## ORIGINATION FORM

### Proposed Revisions to a Standard Plans Index

Index Number: 455-031

Index Title: 30" SQUARE PRESTRESSED CONCRETE PILE -  
HIGH MOMENT CAPACITY

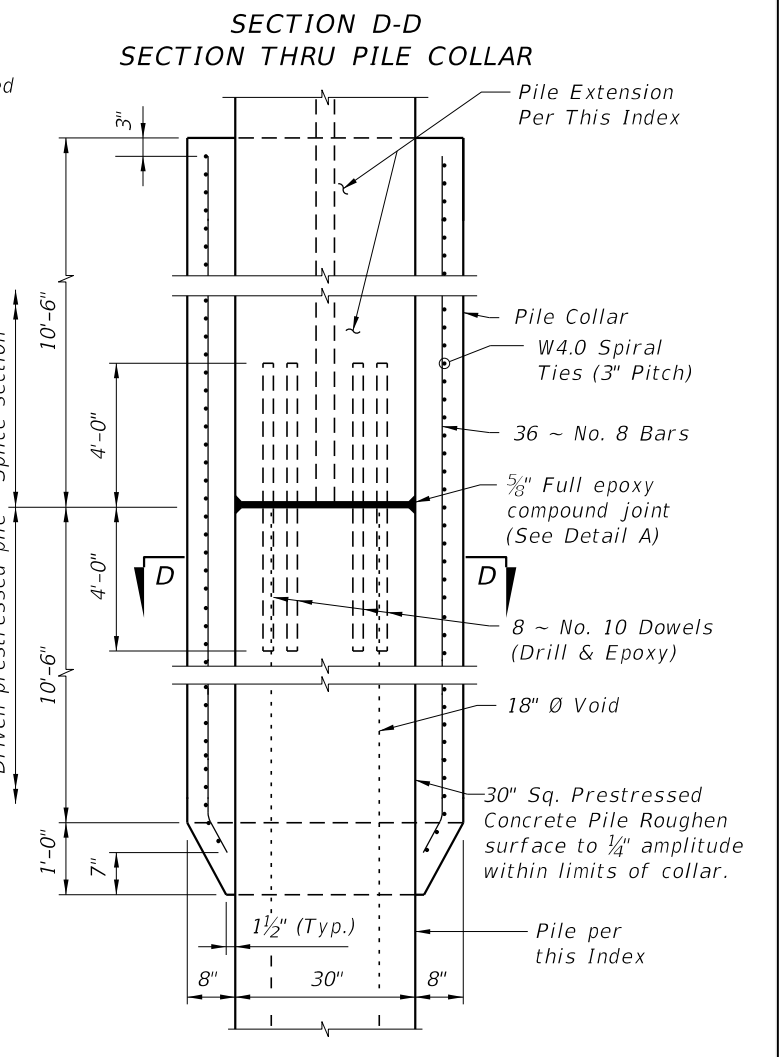
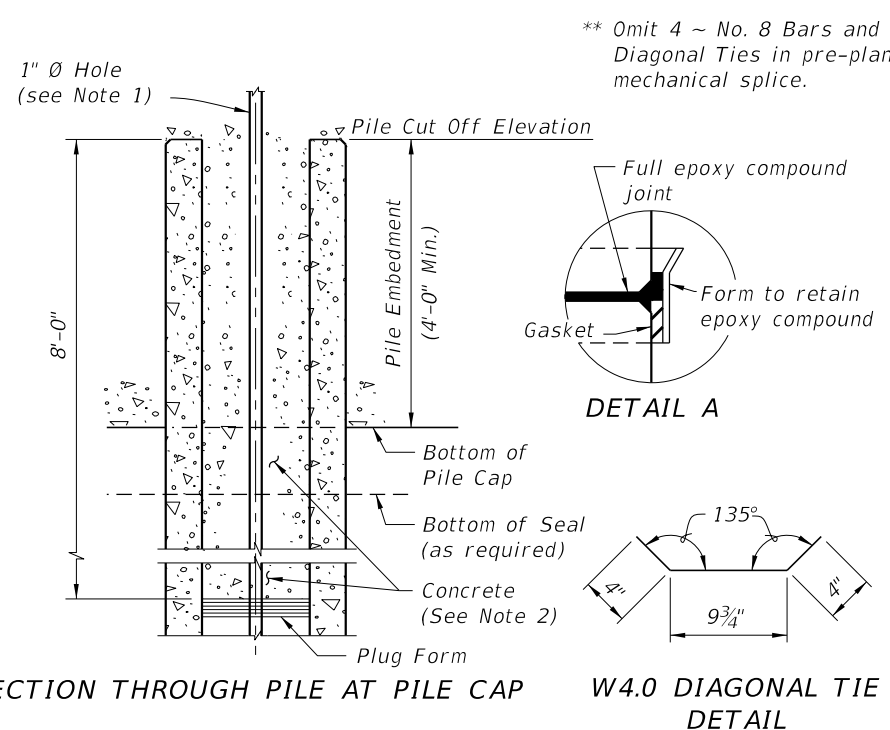
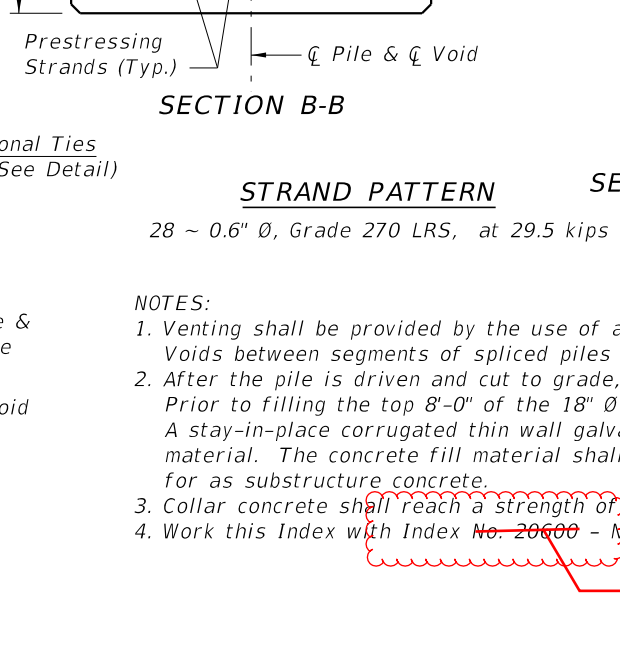
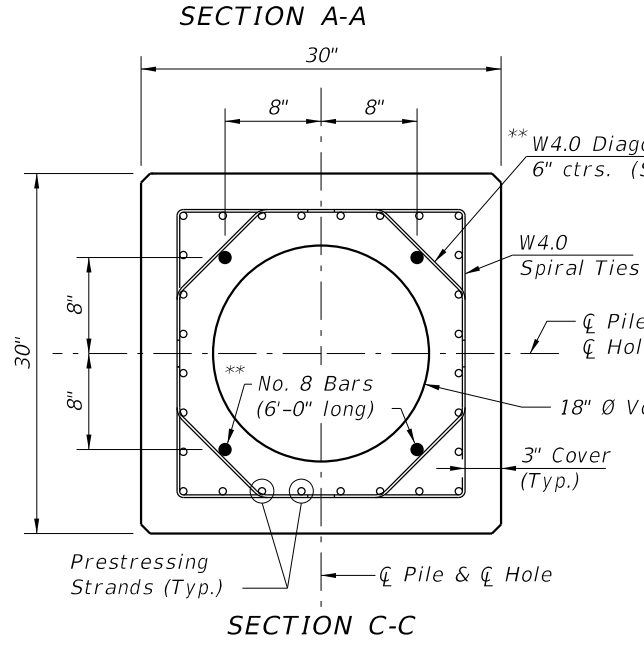
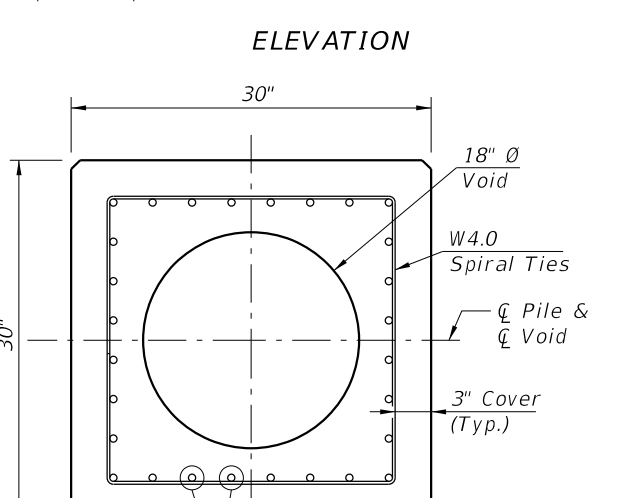
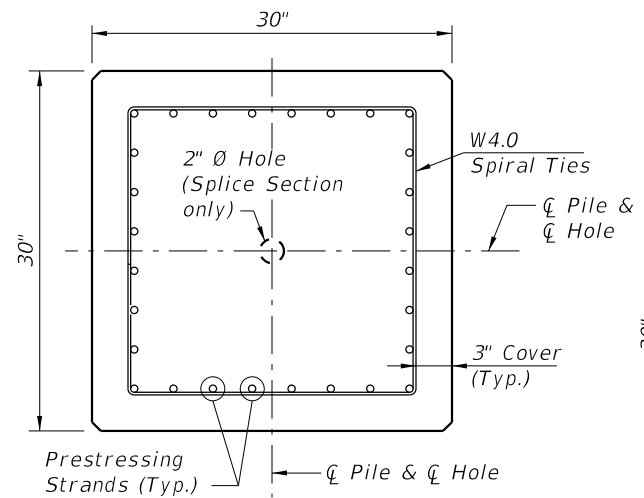
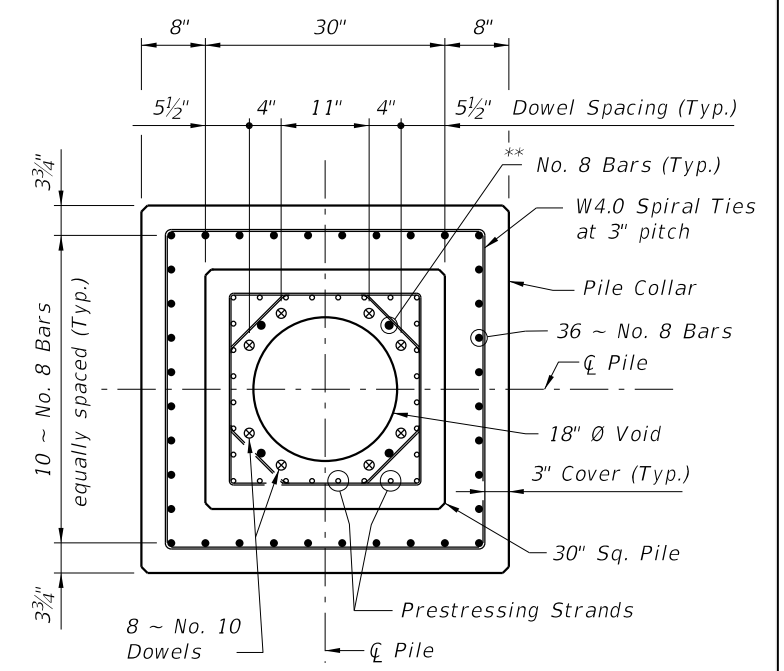
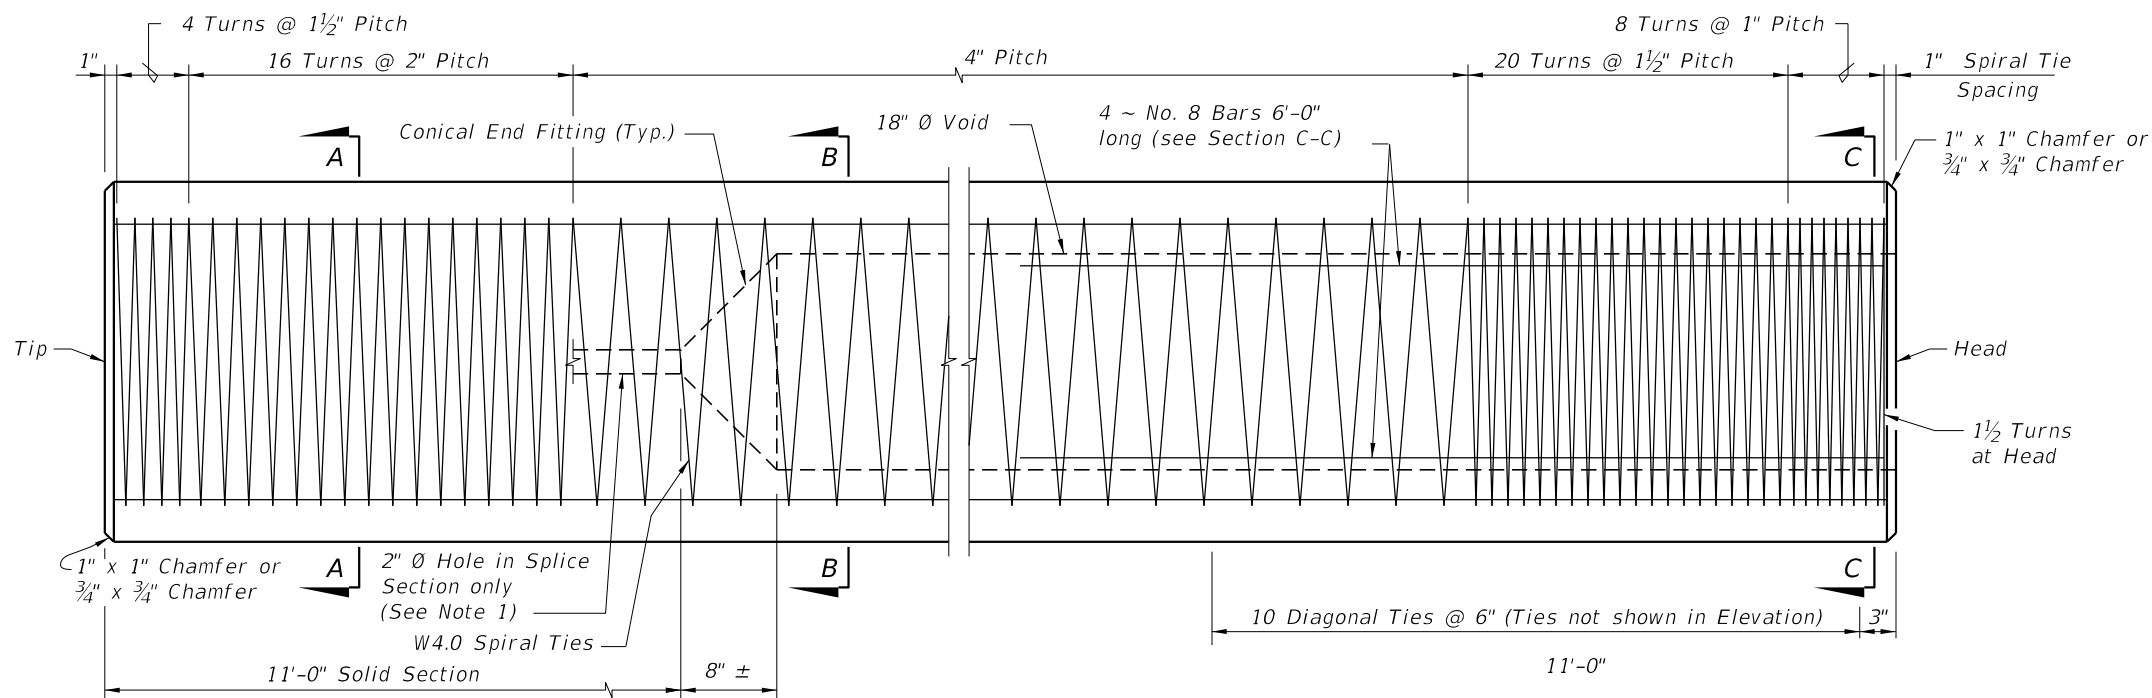
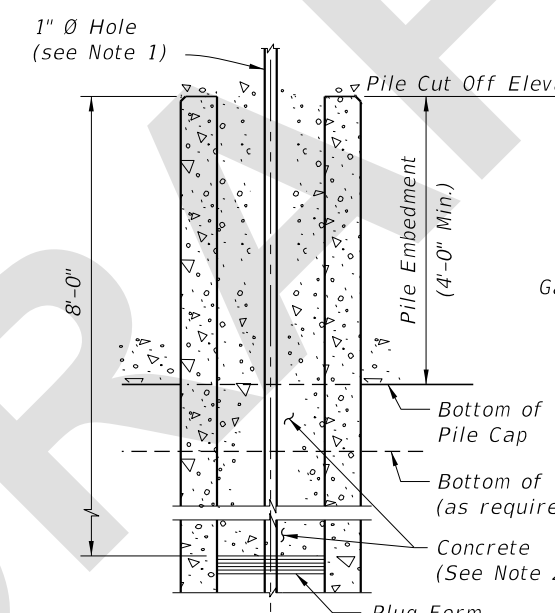
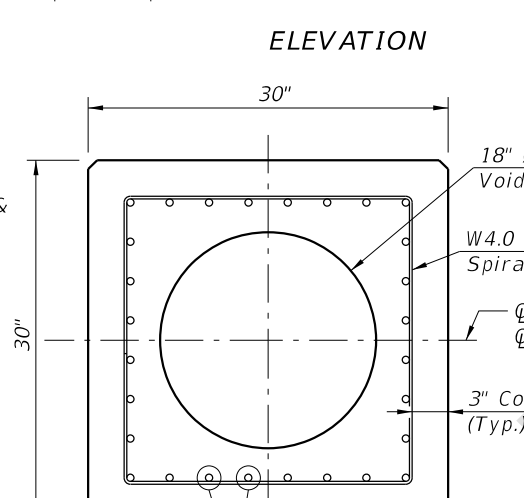
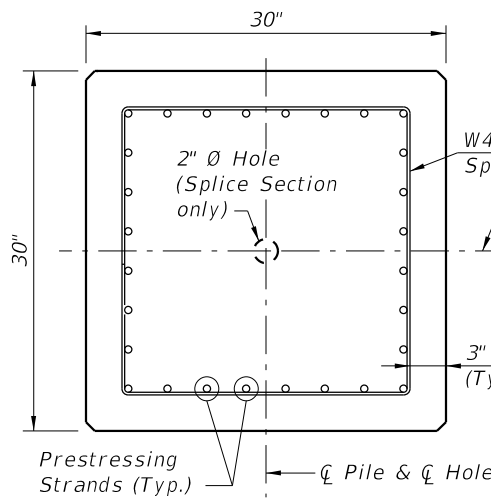
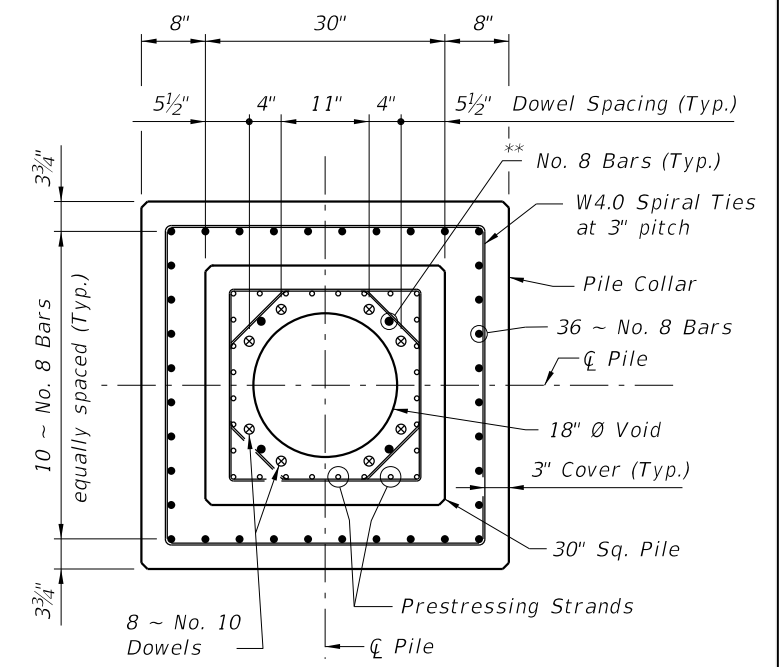
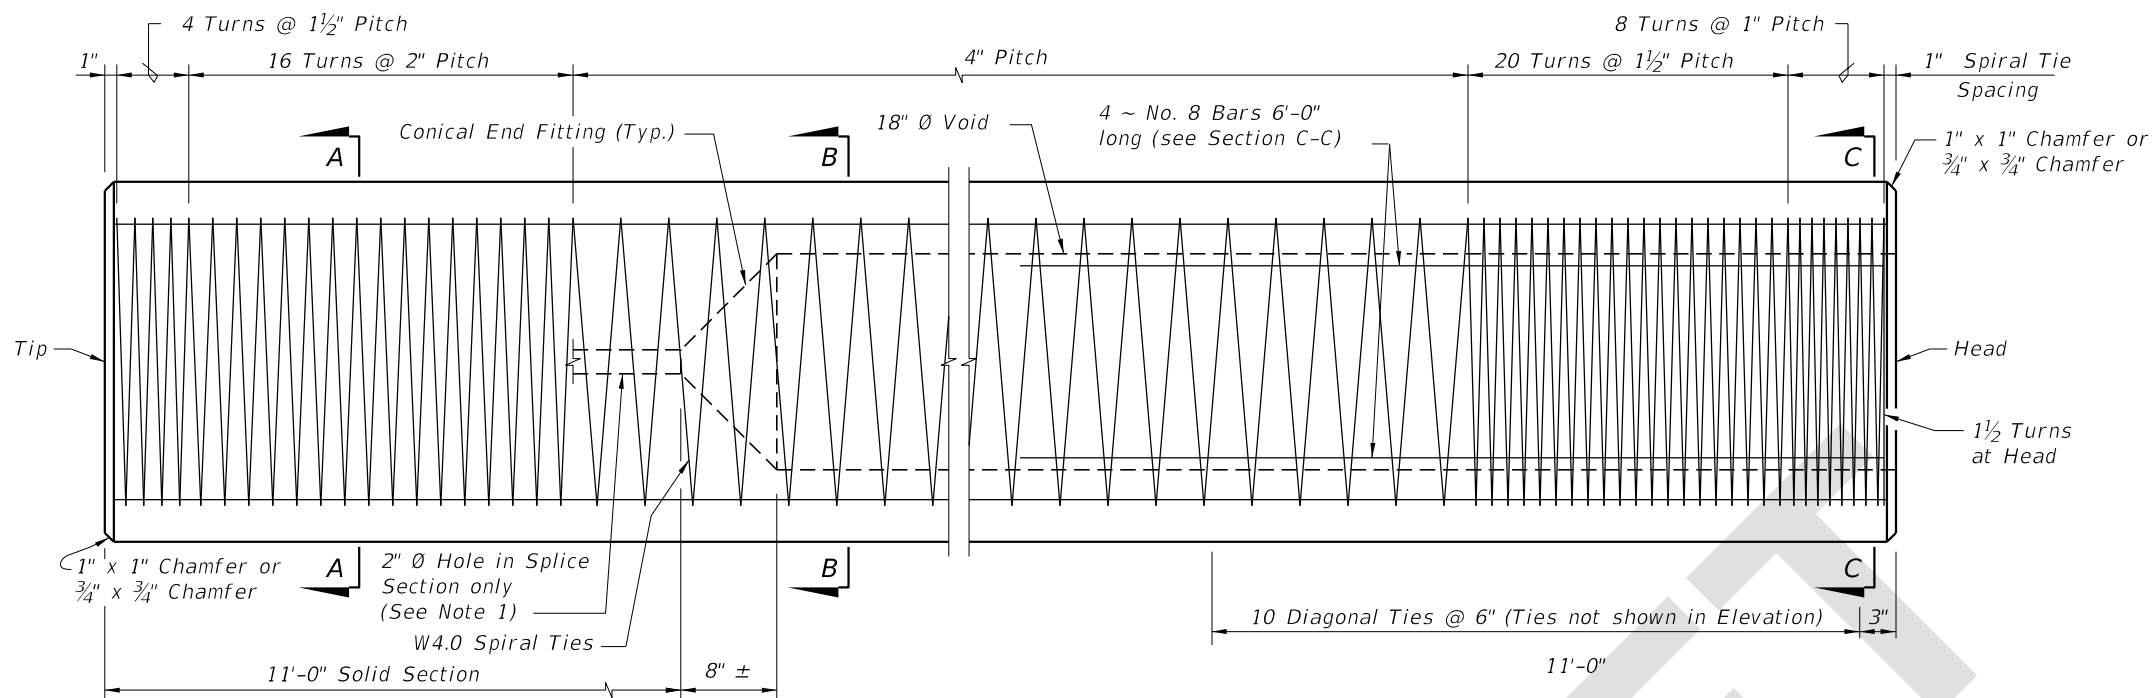
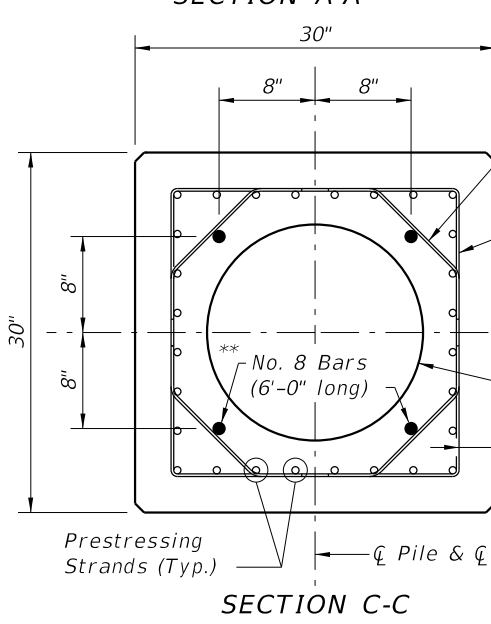
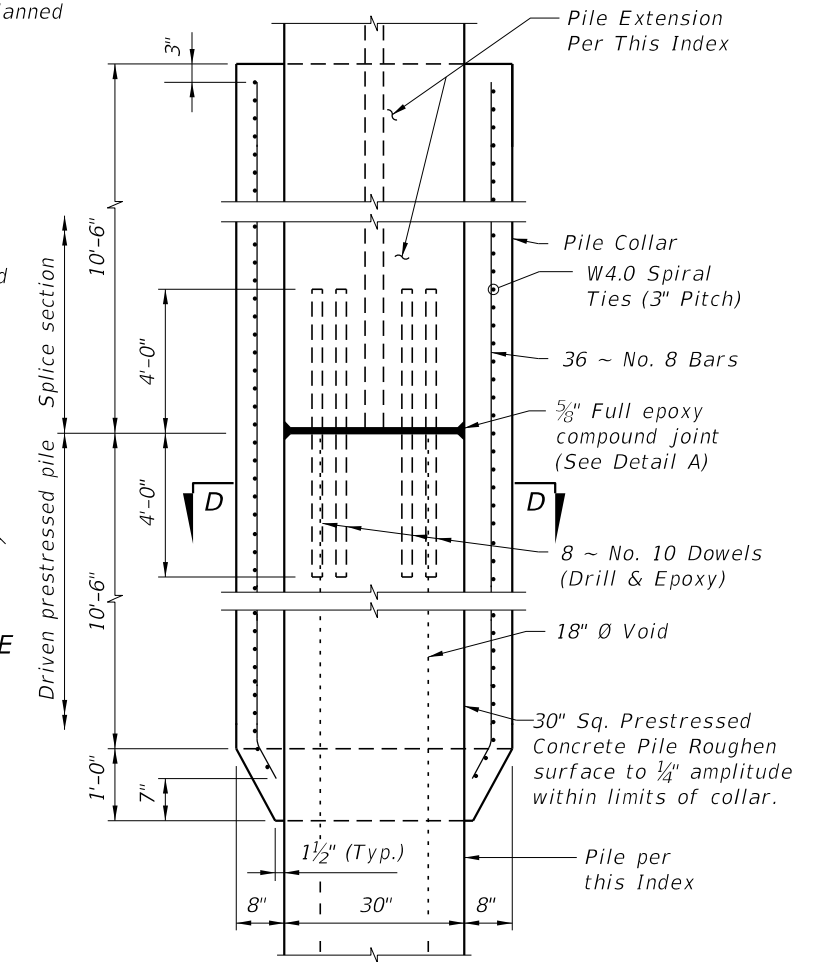
Reverted to the previous version of the Standard.
